City of Surrey  
**ADDITIONAL PLANNING COMMENTS**

Application No.: 7919-0091-00

Planning Report Date: May 9, 2022

City of Surrey  
**PLANNING & DEVELOPMENT REPORT**

project title:  
**PROPOSED RESIDENTIAL  
 DEVELOPMENT  
 138A & 139  
 SURREY**  
 Drawing title:  
**SITE PLAN**

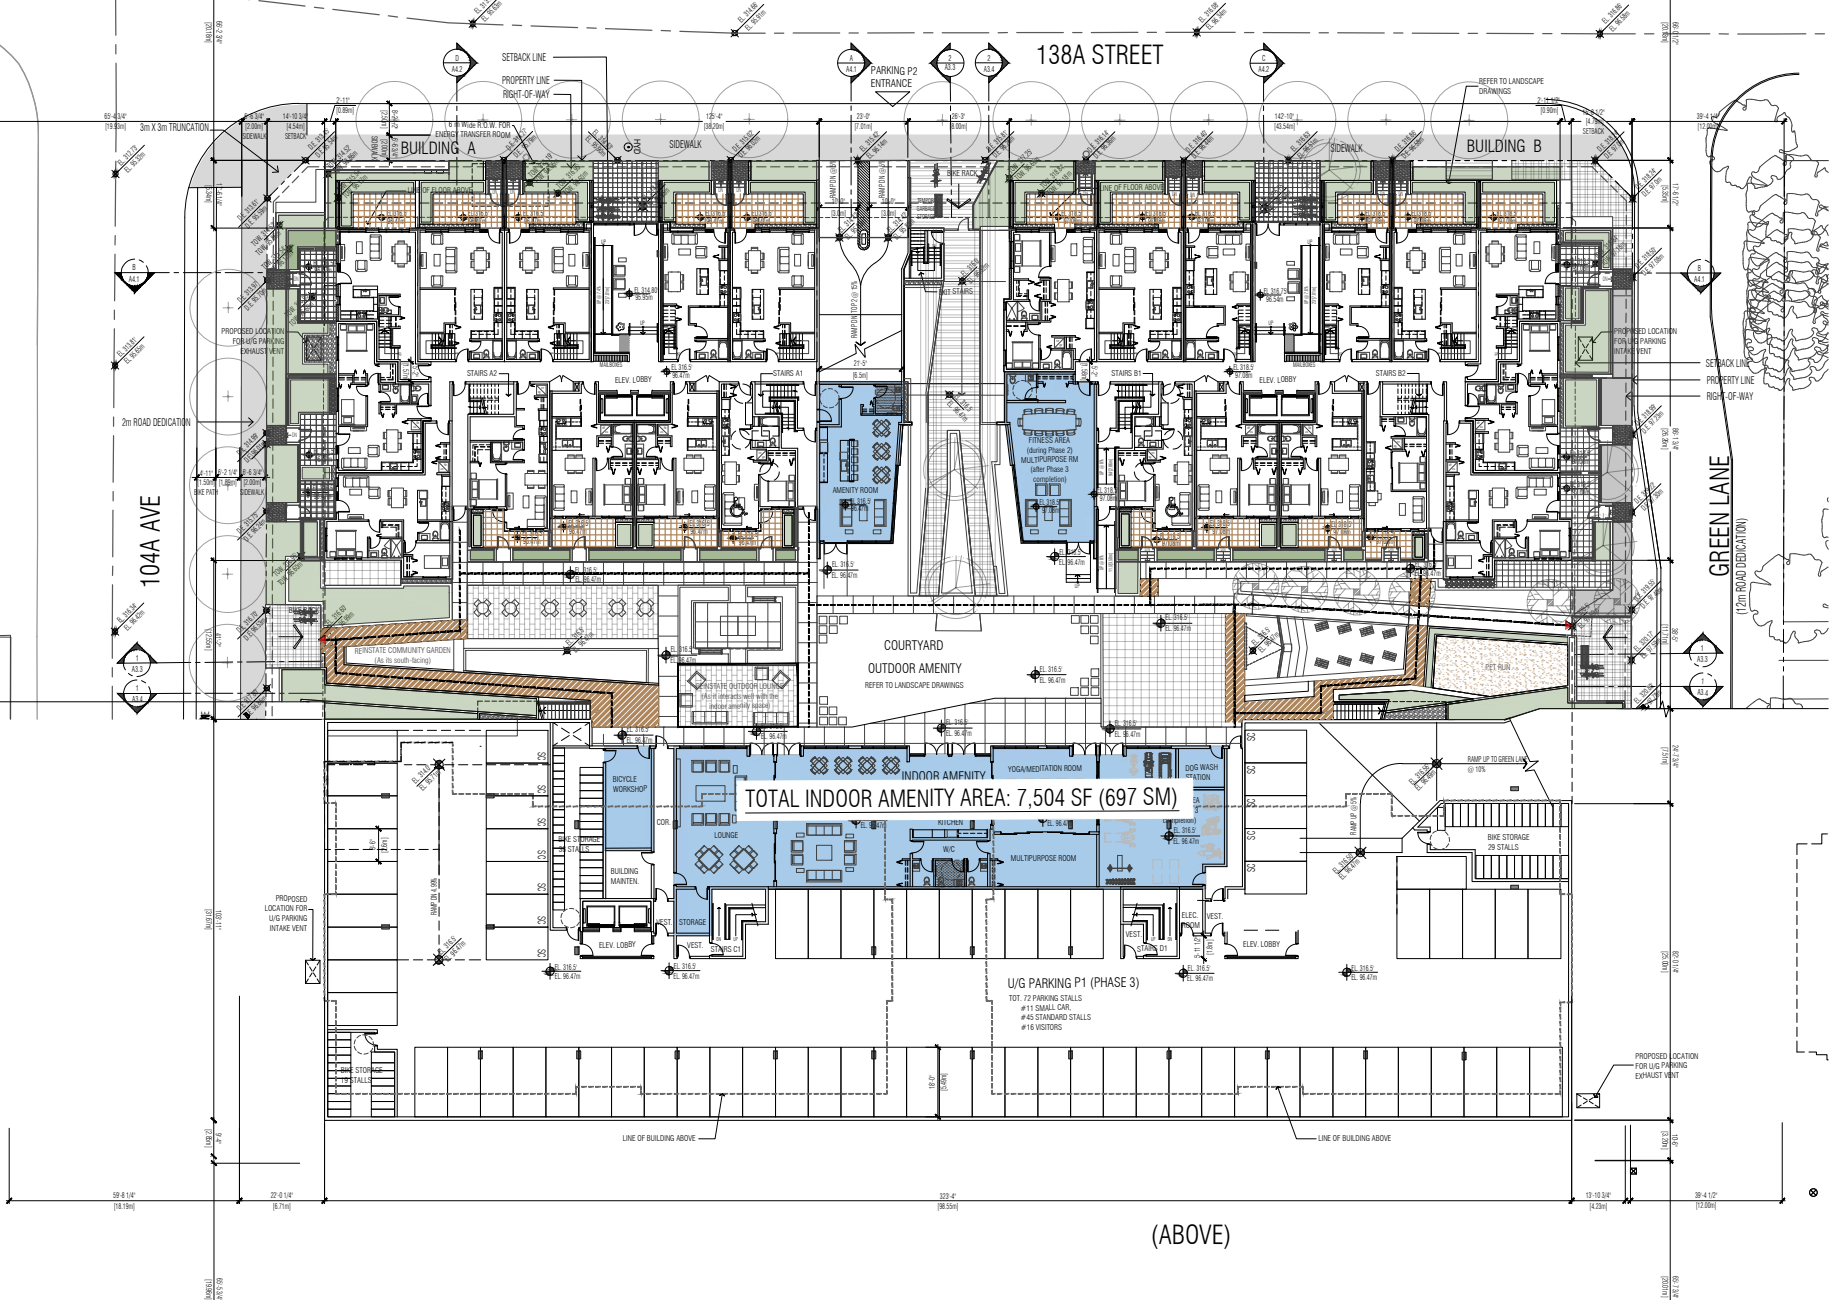
- Consider further development to reduce privacy issues between units in the courtyard and upper corner units.  
*(We have introduced planters between the units on the Ground floor to increase privacy. See A1.1-Site Plan. For the units facing each other along the east west interior courtyards, the bedroom windows will be offset.)*

DRAWING TITLE:  
**LANDSCAPE PLAN UPPER LEVEL**

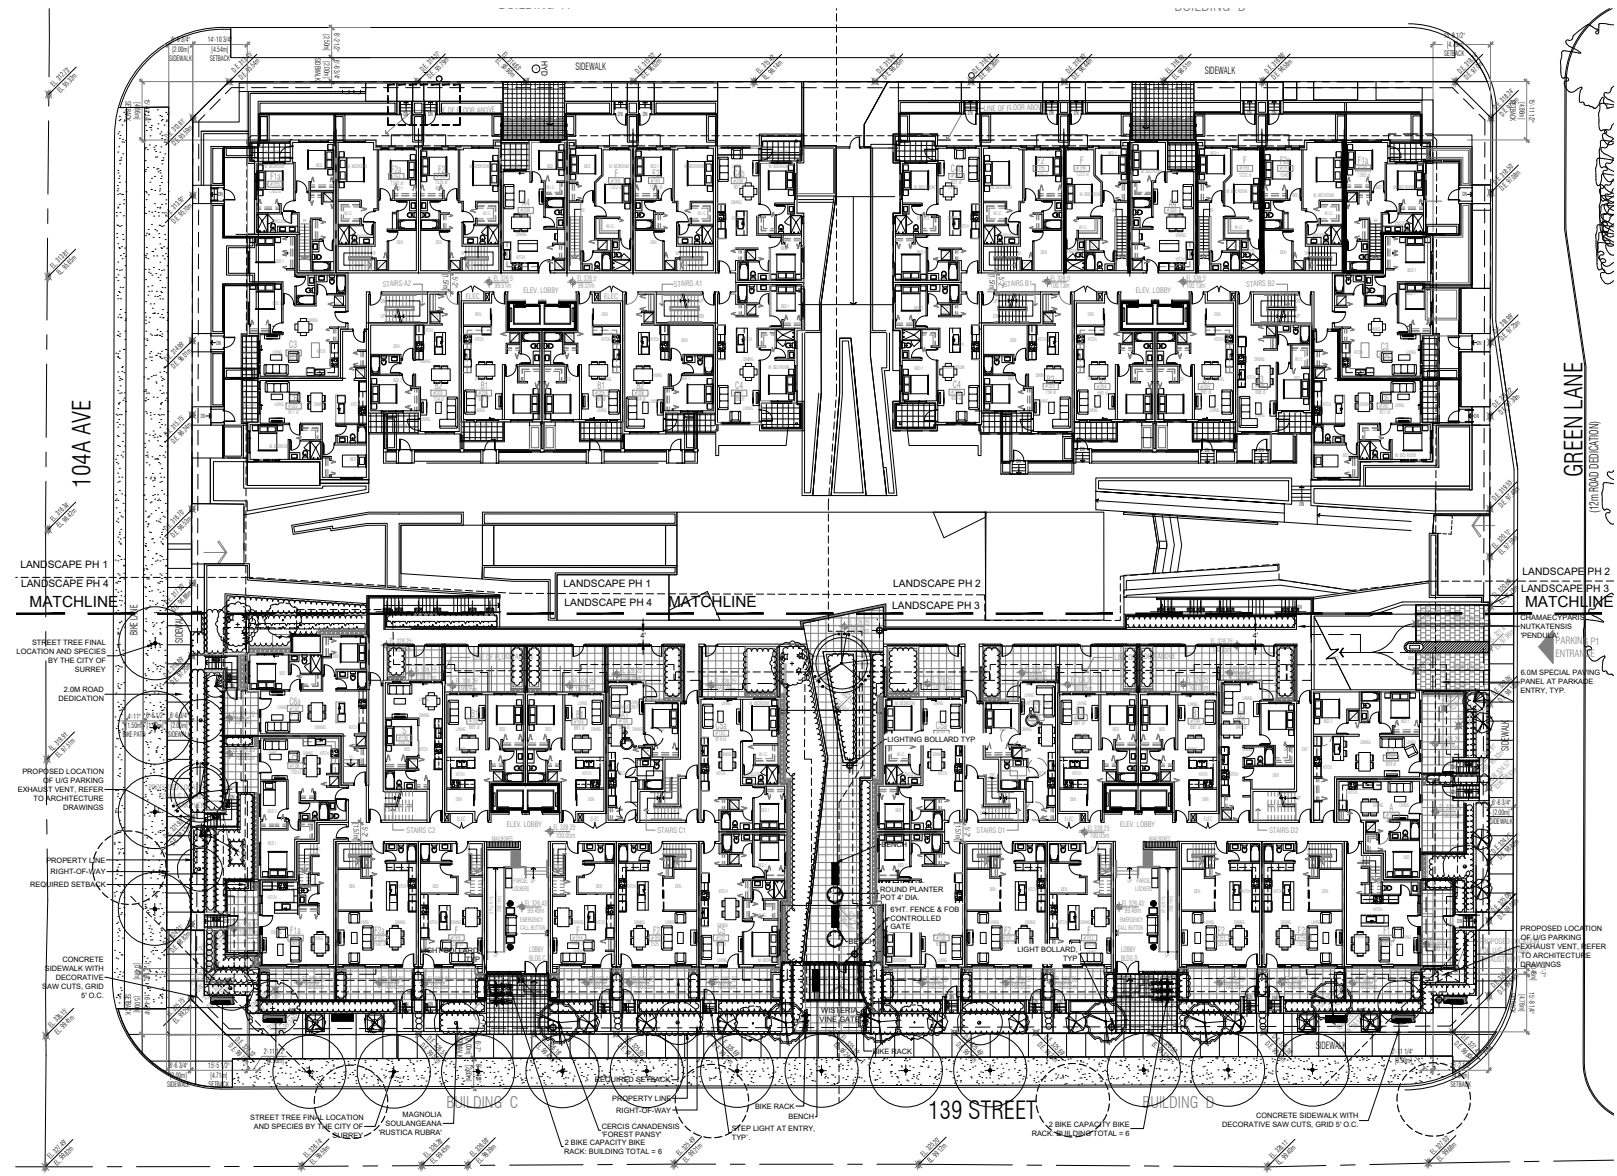
- Consider a thoughtful lighting plan for the courtyard.  
*We will include more details of the landscape lighting plan. Already we have shown specific location for lighting bollards and step lights, but this will be demonstrated on a separate layout. Please refer to the L9 Landscape Lighting Plan.*
